APPLICANT : MAURICE PALESCHUCK
PATENT NO. : 6,994,022
SERIAL NO. : 10/676,681
ISSUE DATE : FEBRUARY 7, 2006
TITLE : AIRCRAFT TRASH MANAGEMENT SYSTEM

REQUEST FOR CERTIFICATE OF CORRECTION

UNITED STATES PATENT AND TRADEMARK OFFICE
CERTIFICATE OF CORRECTION

FIG. 21

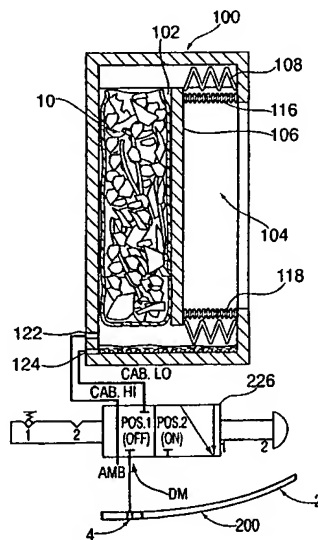
In addition, Applicant seeks to correct minor errors in Figure 21. These amendments to Figure 21 were mailed on July 18, 2007 in a related continuation application Serial No. 11/324,661 (Exh. A) and were accepted in the Office Action dated October 9, 2007 (Office Action Summary enclosed as Exh. B). As seen in Figure 21 of the Certificate of Correction, it has been corrected to properly label Position 2 (ON), the compact and drain position of valve 226, as described on the last paragraph on page 17 of the specification. In addition, the vertical connector line on the right hand side of valve 226 has been adjusted so that it connects to the diagonal arrow connector and an arrow head has been added to the vertical line of the right hand side of valve 226, so that the same functions as correctly set forth in the specification at pages 17-20.

These amendments were made so that the schematic diagram of the four port, two position switch as described on page 17 will properly conform to the specification. Specifically the amendments were necessary to show that when the switch is in Position 2, the ON position, that both Cab hi and Cab low will be connected to dm and amb will be blocked (see specification p.16). The addition of the arrow head was necessary to show the connections when the switch is in Position 2 (ON) (see specification p.16).

In the drawings, Sheet 13, Figure 21 should appear as follows:

FIG. 20

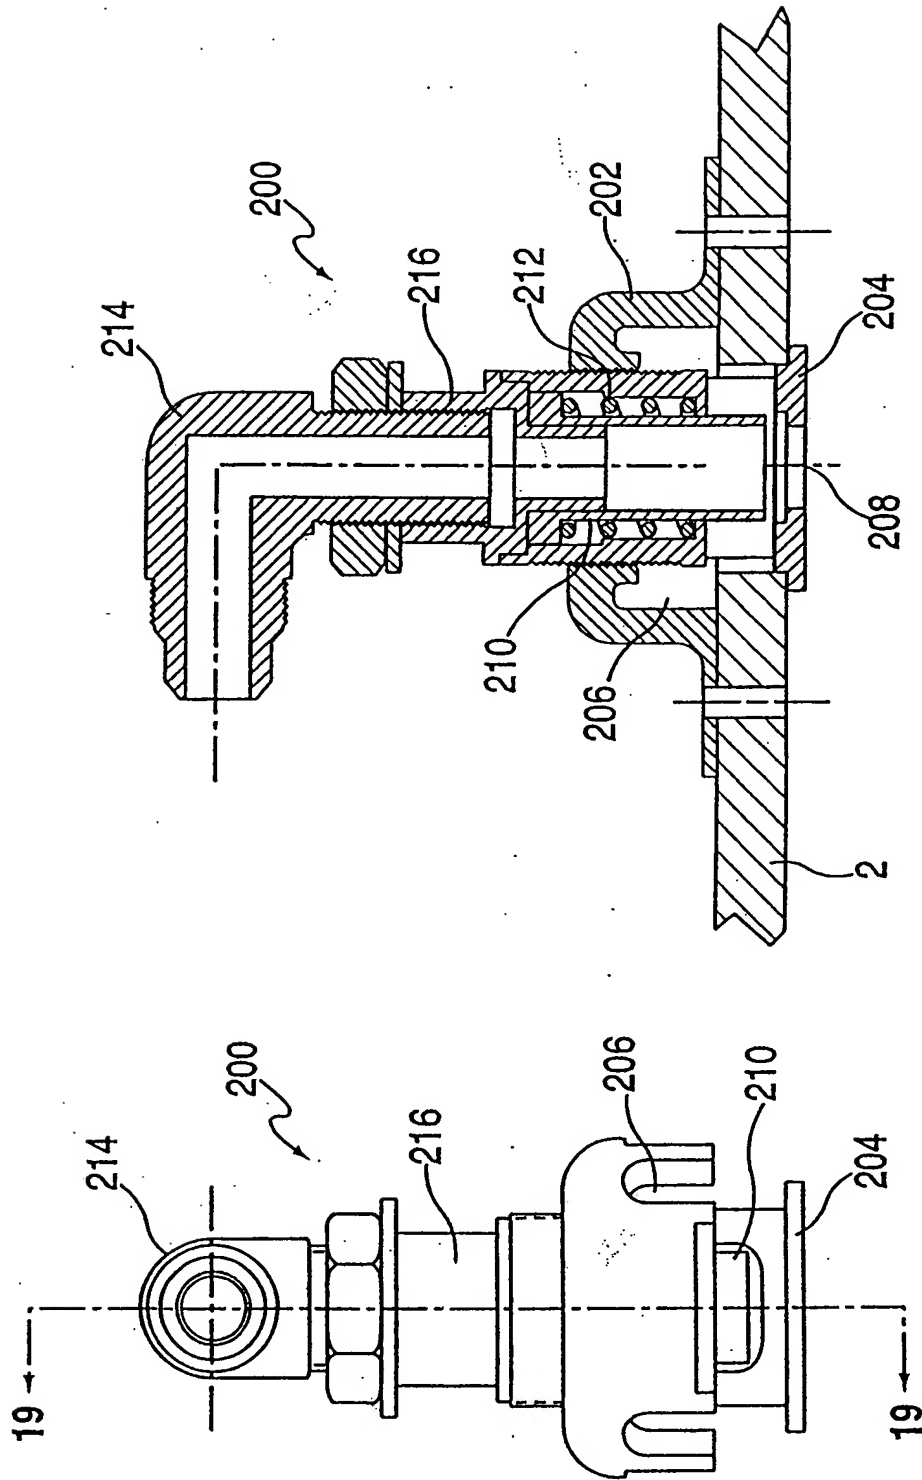
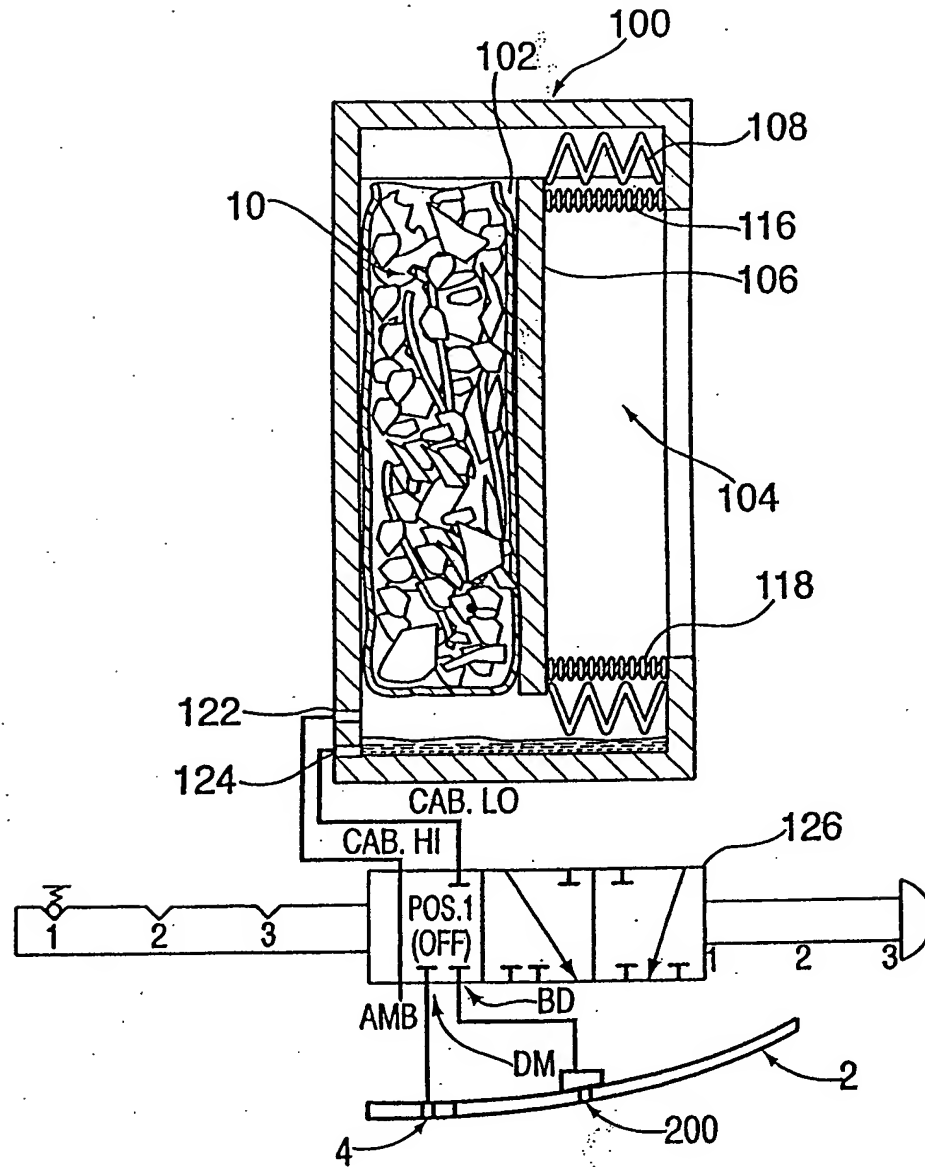
- - Referring now to Fig. 20, the compactor 100 of the invention is illustrated containing a trash filled bag 10 in the compartment 102 ~~104~~ and a schematic illustration of valve assembly 126 coupled to the ports 122, 124, the modified bilge valve 200 and the grey water drain mast 4. - -

Please replace the three (3) sheets of Figs. 18- 21 with the new three replacement sheets of Figs. 18-21 enclosed herewith.

FIG. 21

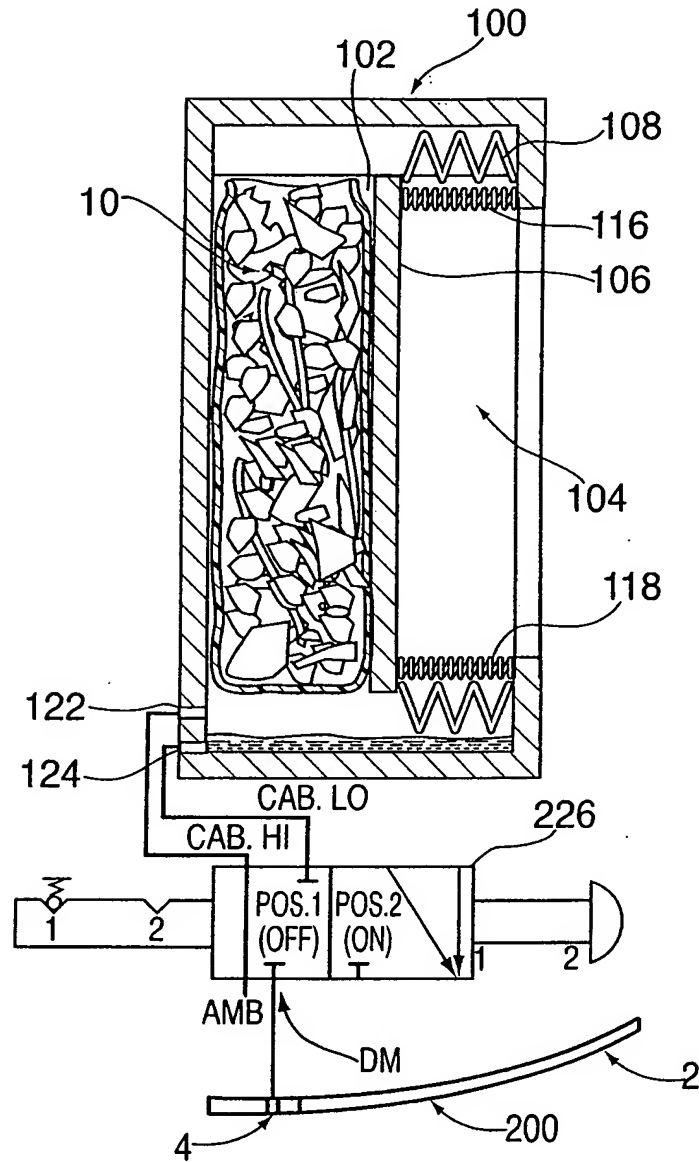
In addition, Applicant seeks to correct the Specification, and amend Figs. 18-21 as was done in the parent case by way of Amendment and to also correct additional minor errors in Figure 21. As seen on the Replacement Sheet for Figure 21 enclosed herewith, Fig. 21 has been corrected to properly label Position 2 (ON), the compact and drain position of valve 226, as described on the last paragraph on page 17 of the specification. In addition, two minor errors in Fig. 21 have been amended. In Fig. 21, the vertical connector line on the right hand side of valve 226 has been adjusted so that it connects to the diagonal arrow connector and an arrow head has been added to the vertical line of the right hand side of valve 226, so that the same functions as correctly set forth in the specification at pages 17-20.

These amendments were made so that the schematic diagram of the four port, two position switch as described on page 17 will properly conform to the specification. Specifically, the amendments were necessary to show that when the switch is in Position 2, the ON position, that both Cab hi and Cab lo will be connected to dm and amb will be blocked (see specification p.16). The addition of the arrow head was necessary to show the connections when the switch is in Position 2 (ON) (see specification p.16). It is not believed that these corrections add any new matter to the patent since they serve to simply illustrate the position of the valve as specifically described in the specification as noted above.
